**PLAN COMMISSION MEETING
IN PERSON AND VIA ZOOM
TUESDAY, APRIL 14, 2026 – 4:00 PM
CITY HALL – SECOND FLOOR**

MINUTES

*b. Review and possible recommendation to the City Council relating to a **Certified Survey Map** for the properties known as Lots 12 and 13 in the Klement Business Park (parcel numbers 226-0514-1742-000 and 226-0514-1742-003) (SPR-2025-18) (Draeger, Director of Neighborhood and Building Services)*

- c. *Review and possible action relating to a Site Plan Review for two Industrial Buildings located on Lots 12 and 13 in the Klement Business Park (parcel numbers 226-0514-1742-000 and 226-0514-1742-003) (SPR-2025-18) (Draeger, Director of Neighborhood and Building Services)*

CERTIFIED SURVEY MAP NO. _____

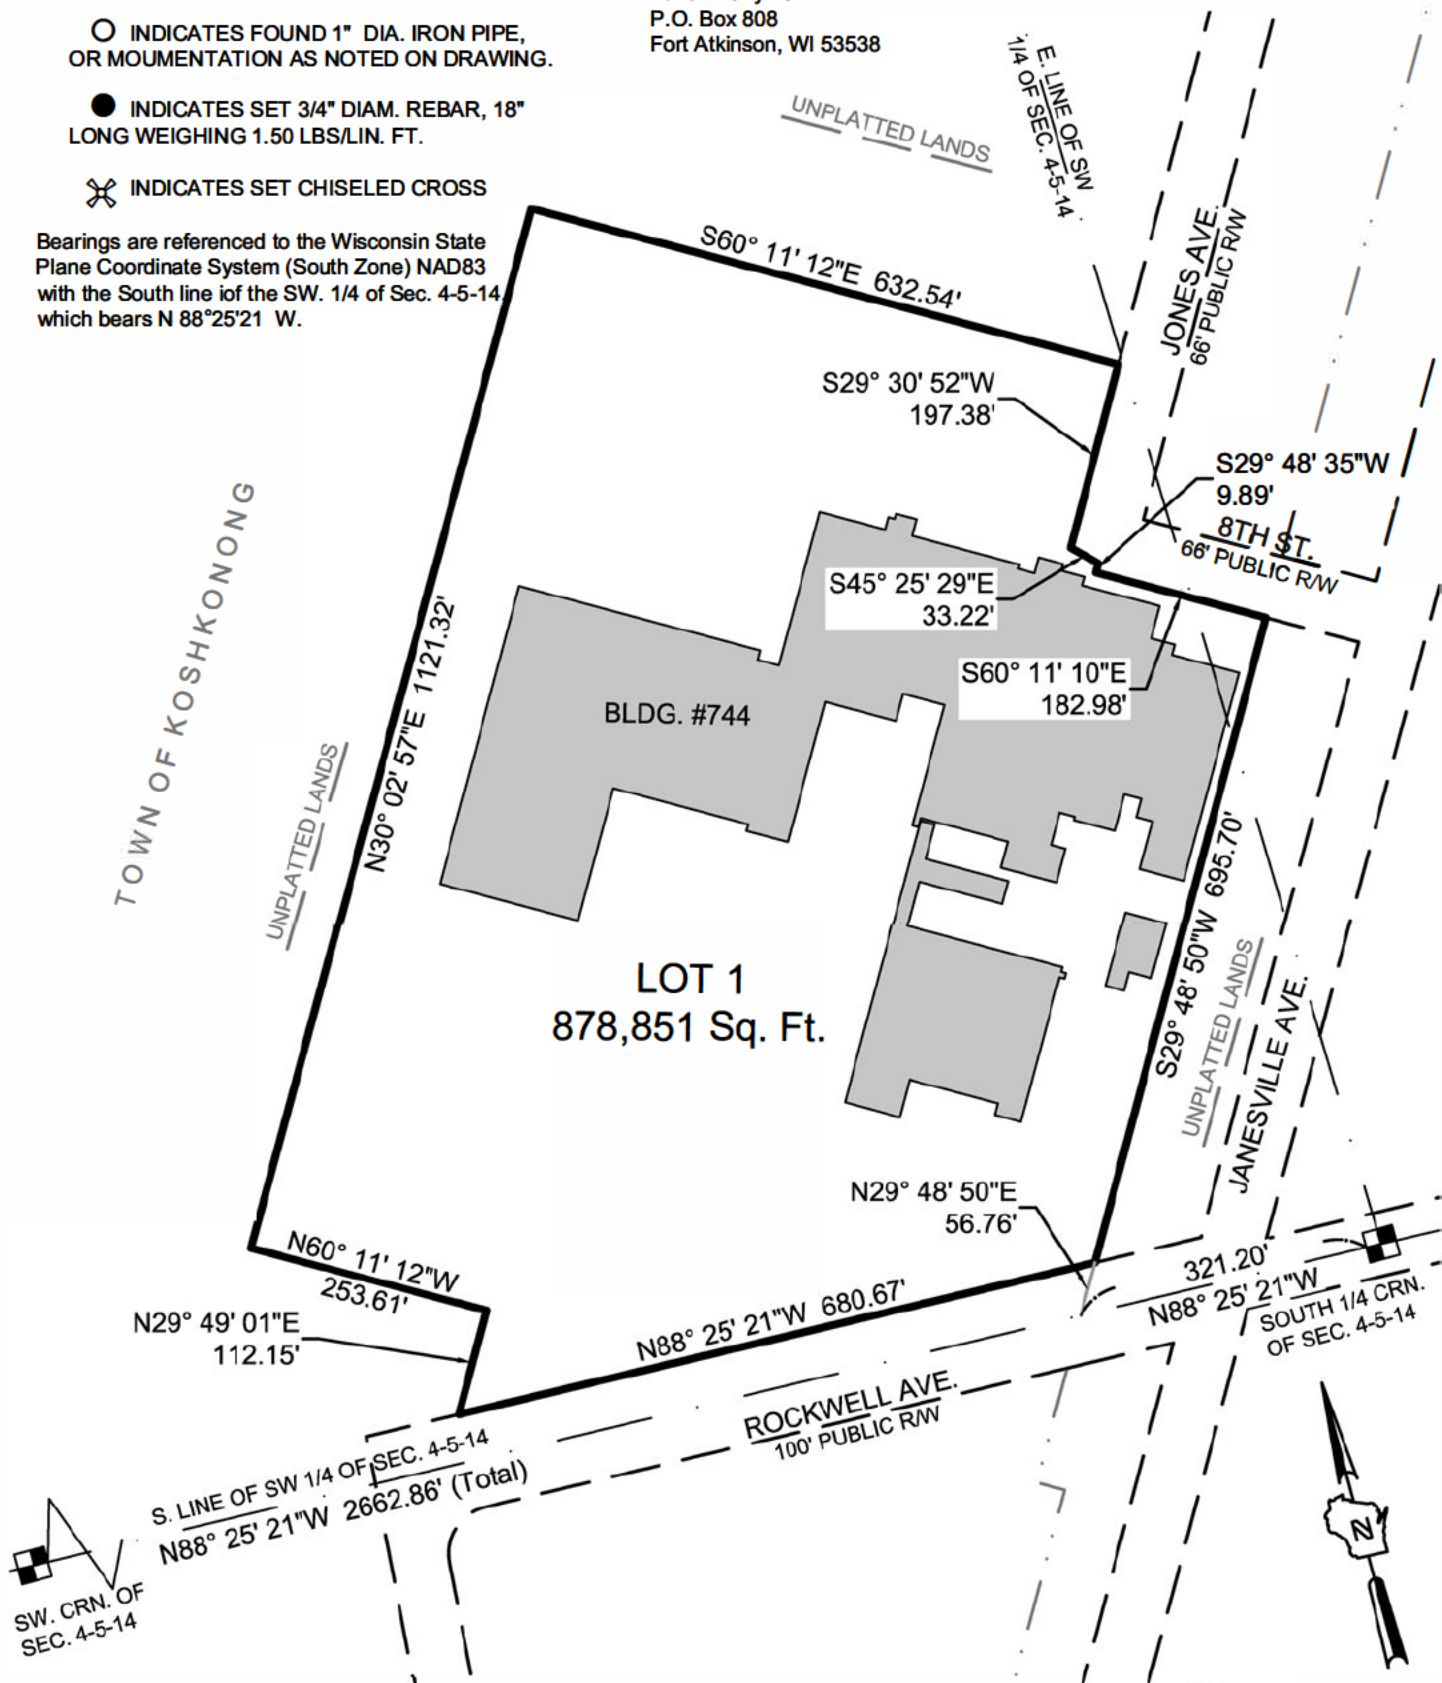
Per Ch. 236, Wis. Stats. and Ch. A-E7, Wis. Admin Code: s. 236.20(2)(i) Bearing Basis: Should the North Reference in Note 2. Be changed from "Dane" to "Jefferson" County s. 236.34(1m)(a) Each sheet of the final CSM must be signed, sealed and dated by a WI Professional Land Surveyor.

Per Ch. 70 City of Fort Atkinson Land Division and Development Ordinance: s. 70.06.01(1)(b) Contact information. Name, mailing address, email address, and phone number of the owner, developer and land surveyor. Add the underlined information to the final CSM.

s. 70.06.01(1)(d) Inset Map. An inset map of the area showing the general location of the proposed subdivision in relation to U.S. Public Land Survey section and quarter-section lines and abutting and nearby public streets and highways. The inset map shall be oriented on the sheet in the same direction as the main drawing. An inset map shall be added to the final CSM. In Note 1. verify the field work completion date. It is shown as August 12th and 14th, 2026. In line 2 remove the phrase "in accordance with the

1 NORTH ELEVATION
A300 3/16" = 1'-0"

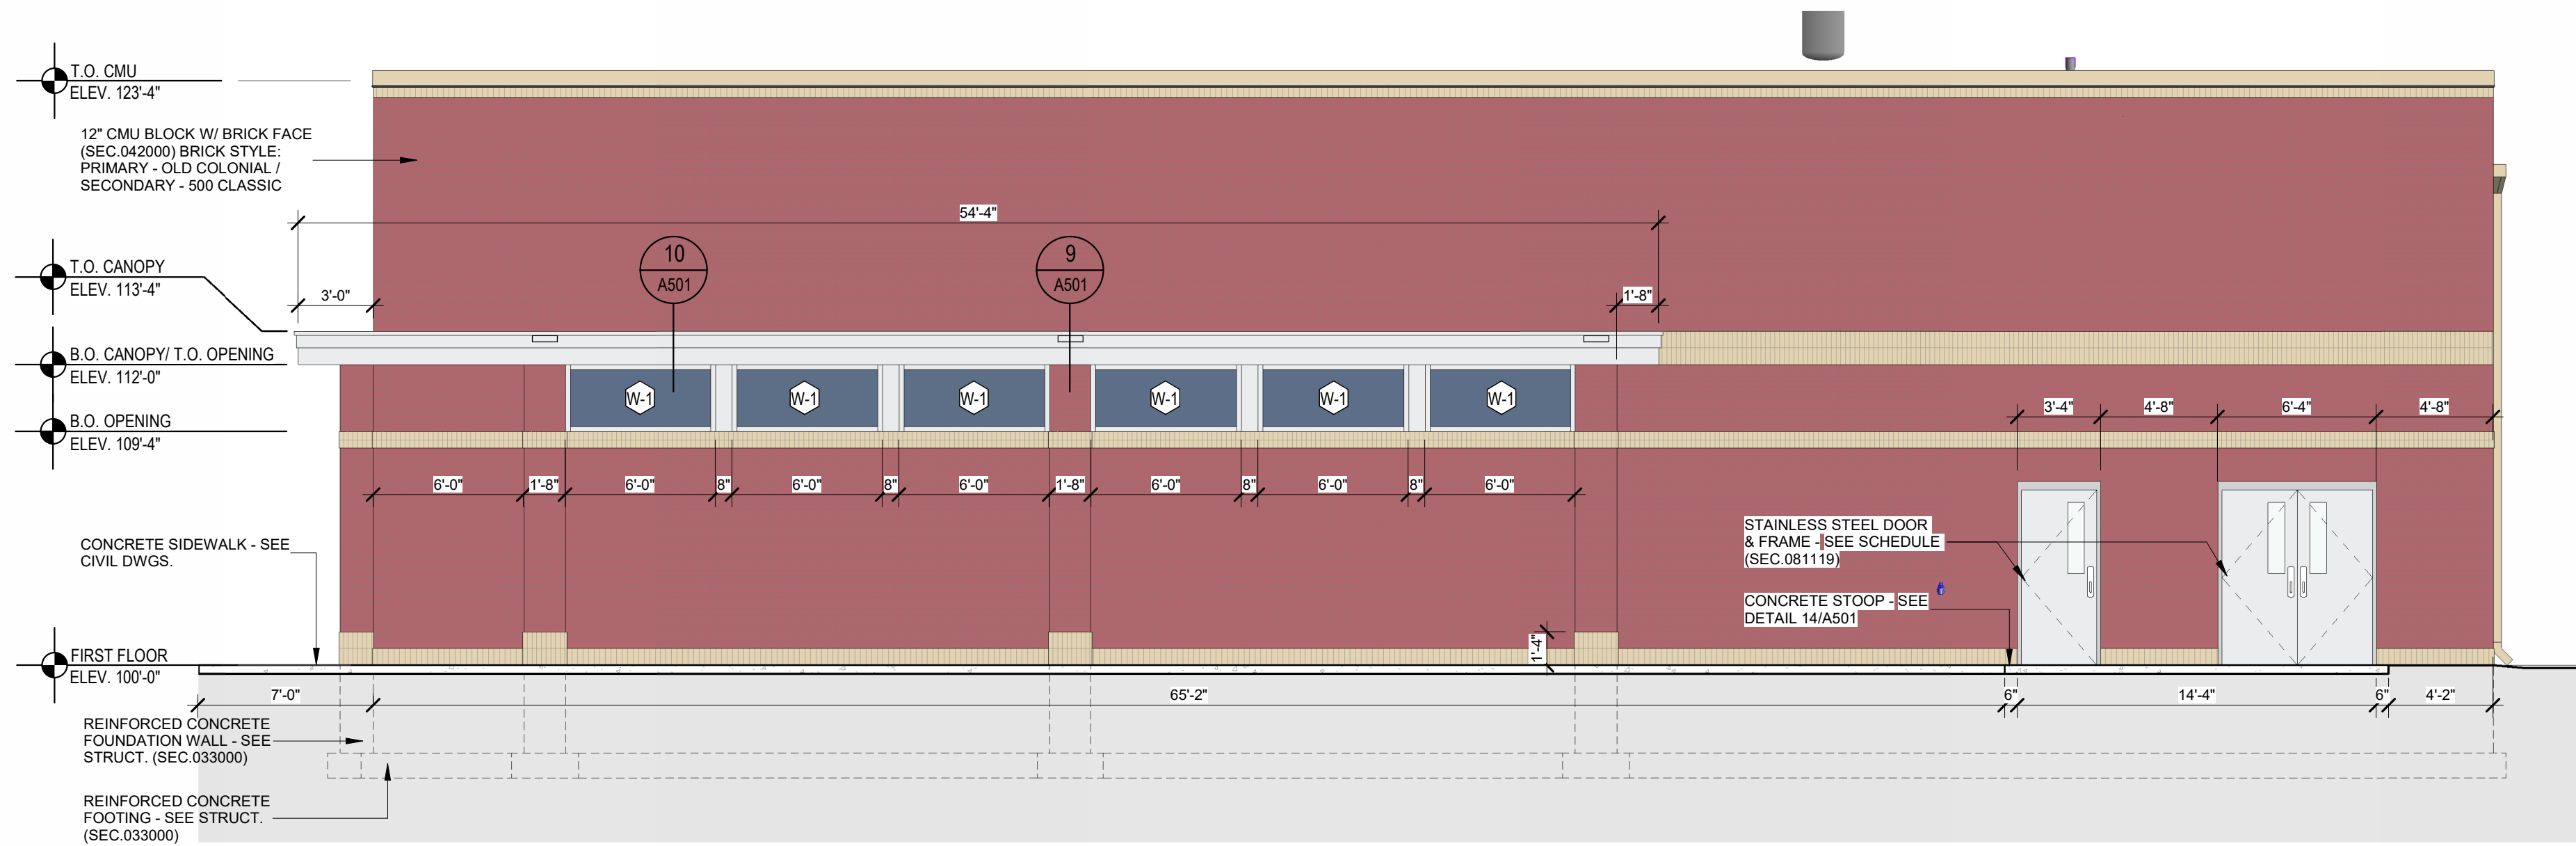
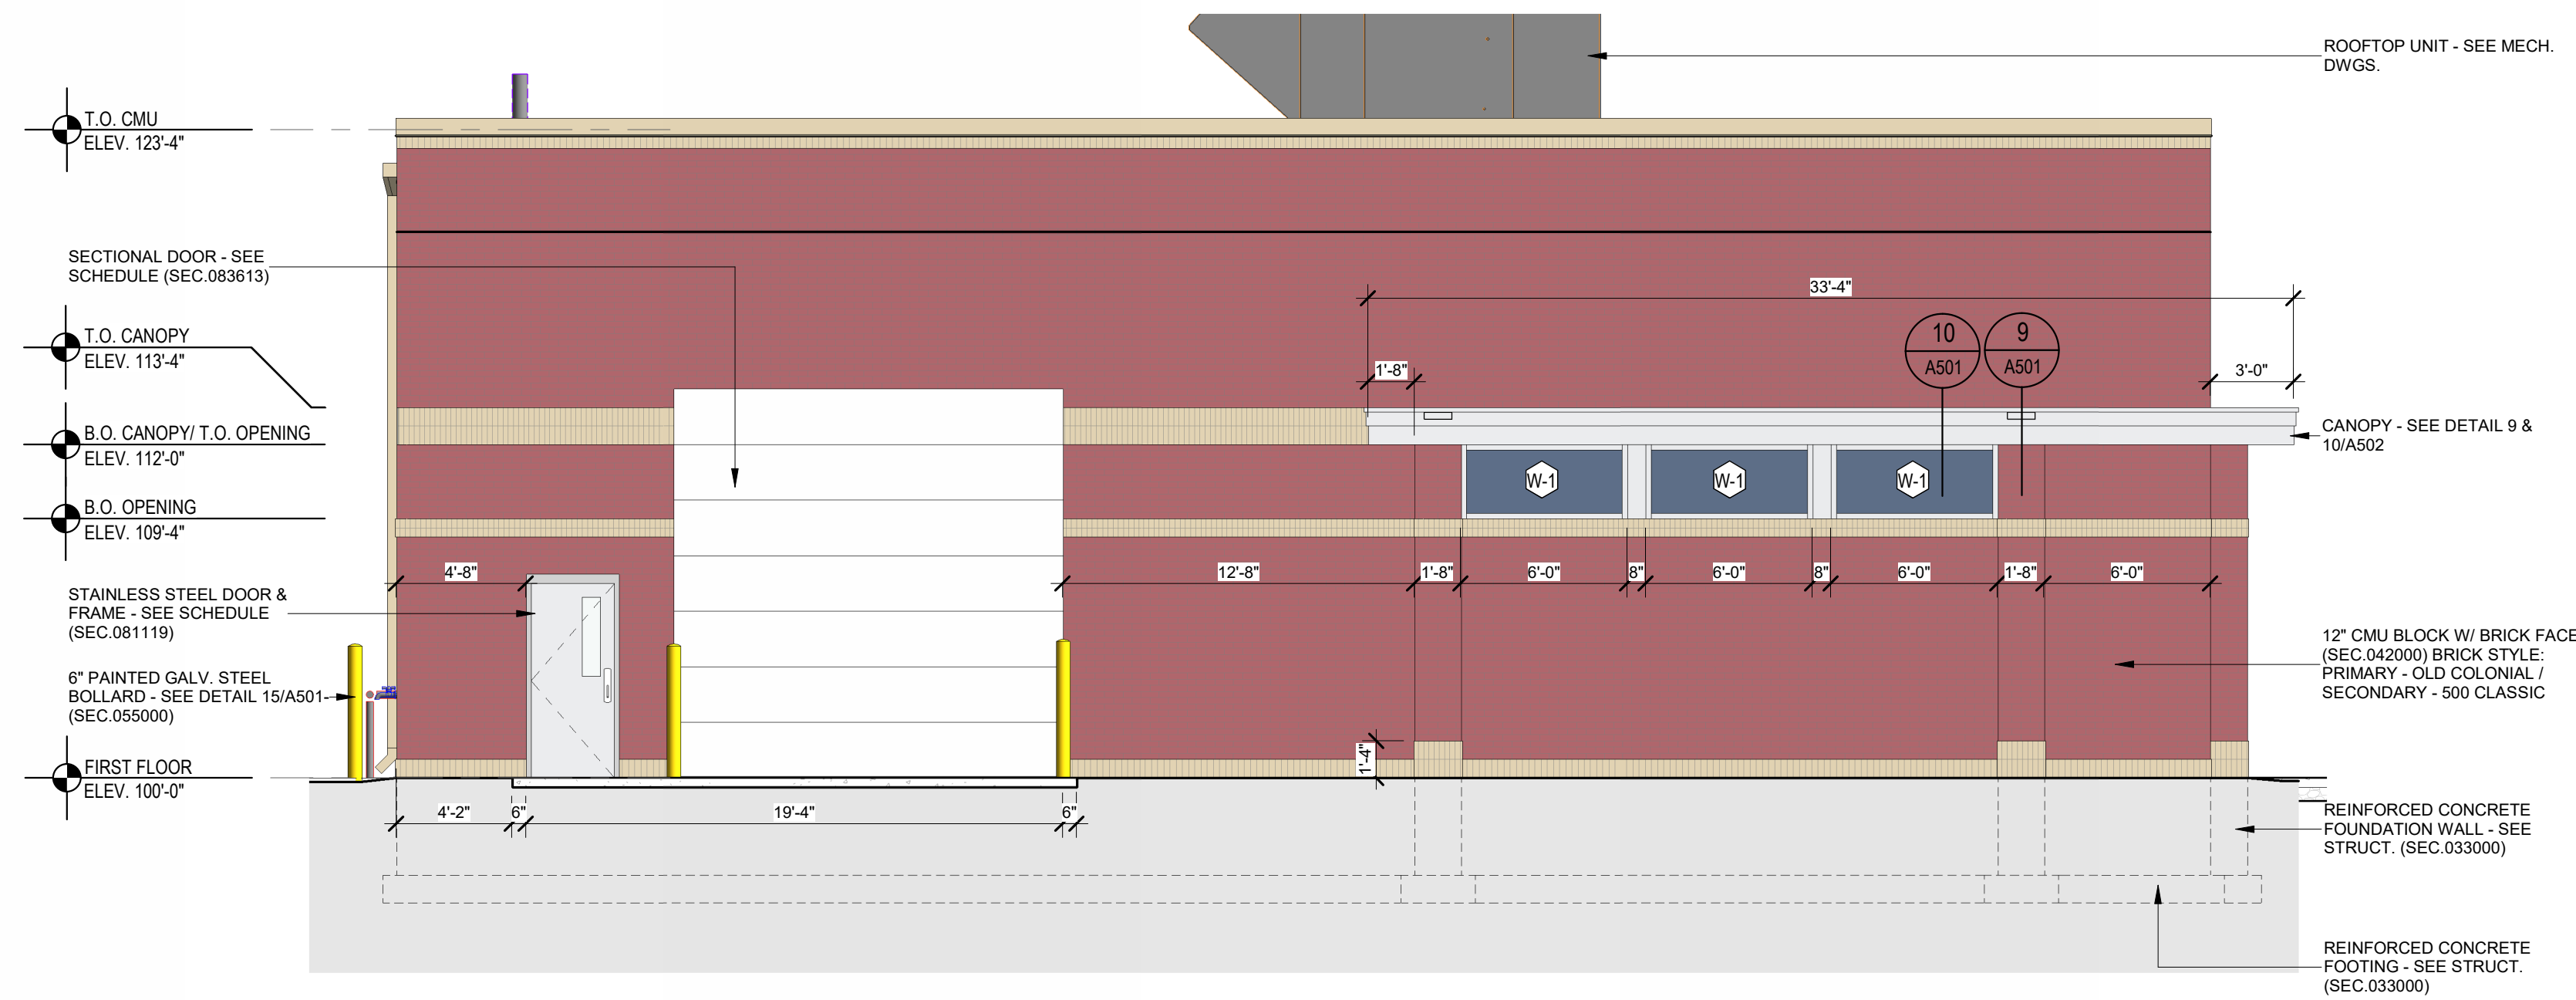
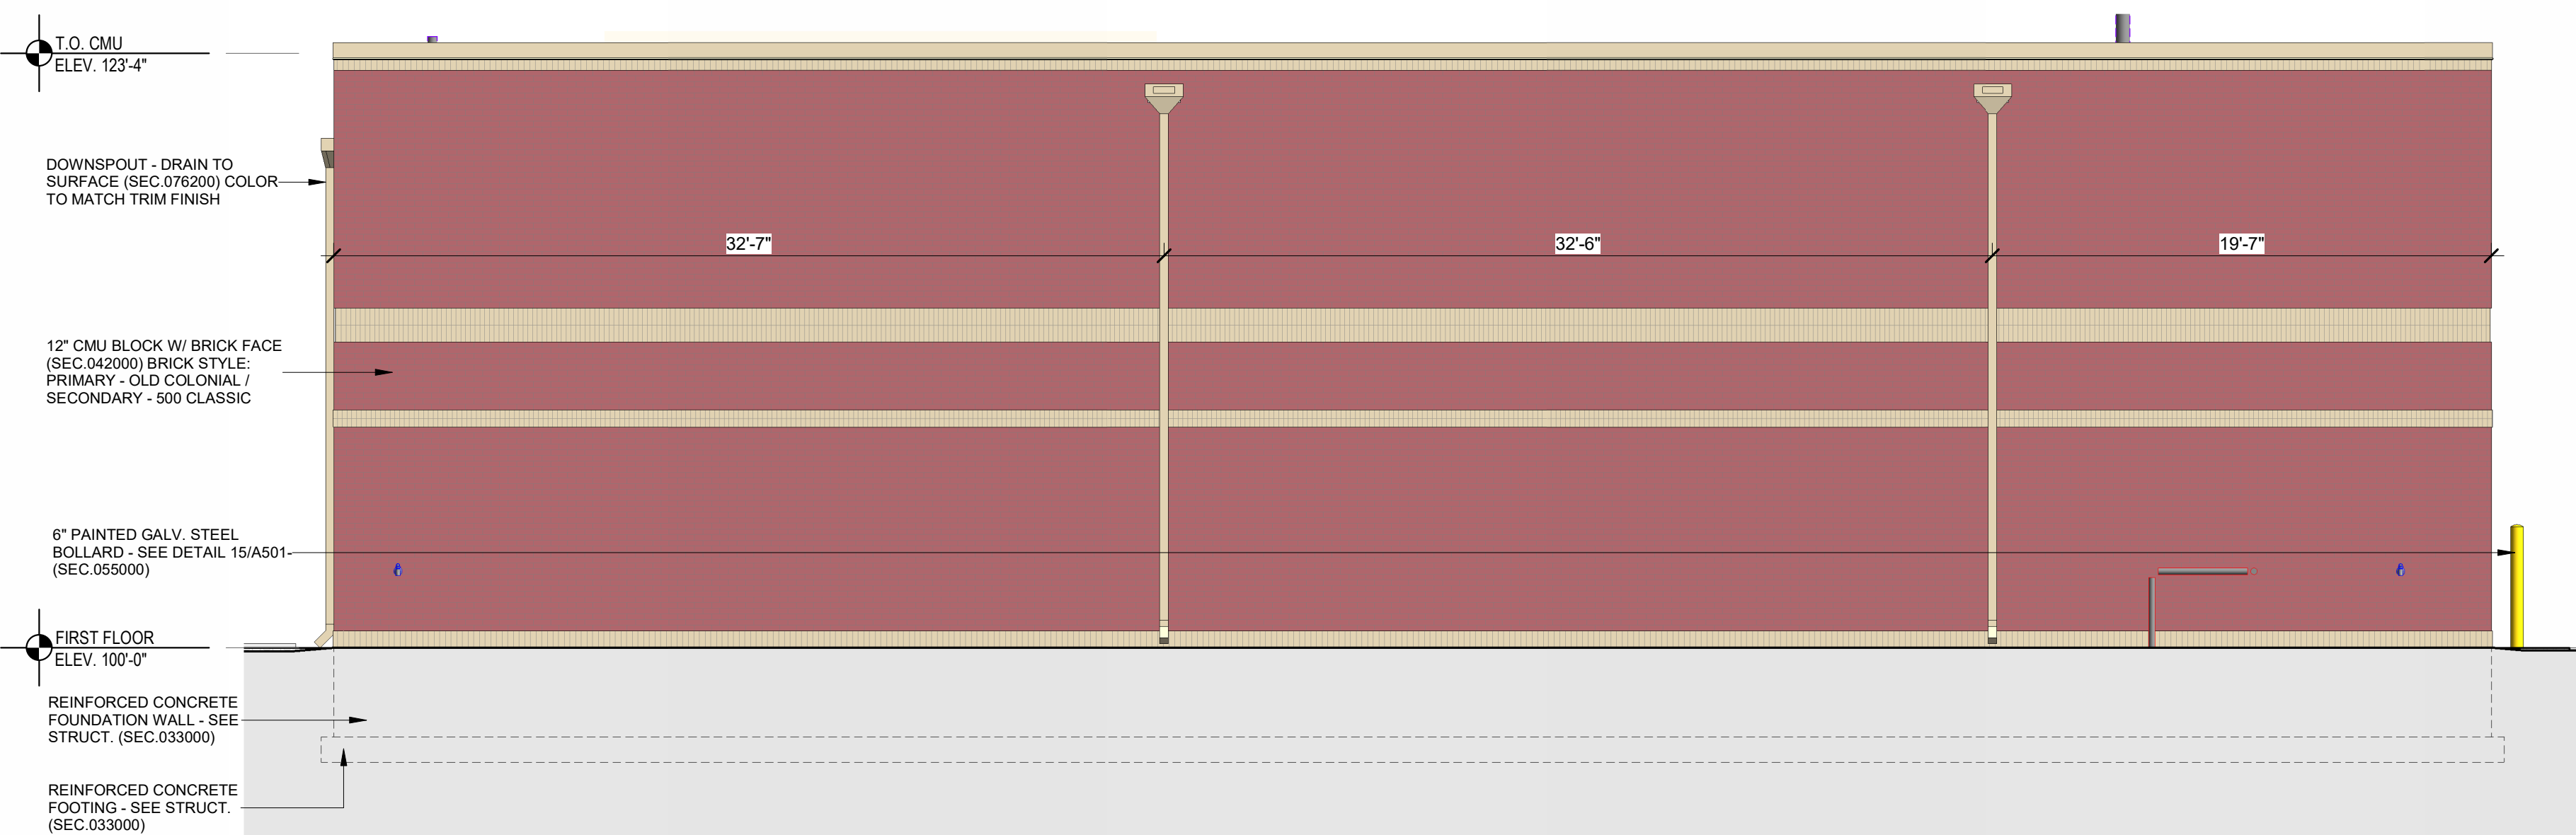
Kessenich questioned the materials or color of the canopies on the exterior of the building. Director Draeger indicated that it was not clear from the plan and would bring it back to the applicant.

Ciccarelli noted that this building will be a flagship building and at the gateway to the business park. He suggested enhancing the side façade to better resemble the front. While mindful of project costs, he felt it was worthwhile to raise this consideration early in the planning process. He also inquired about the roof plans and whether a skylight is planned, noting its potential to improve employee satisfaction. Director Draeger indicated that we do not typically see roof plans unless there would be mechanical or other items needing review. Finally, Ciccarelli proposed keeping the roof plans open to potential future solar development and listed several local businesses utilizing solar.

1. Details relating to the material and color of the canopies
 2. City Council approval CSM
 3. Minor changes to the site plan and facade can be City Staff can be approved administratively, but major changes come back to this body for approval.
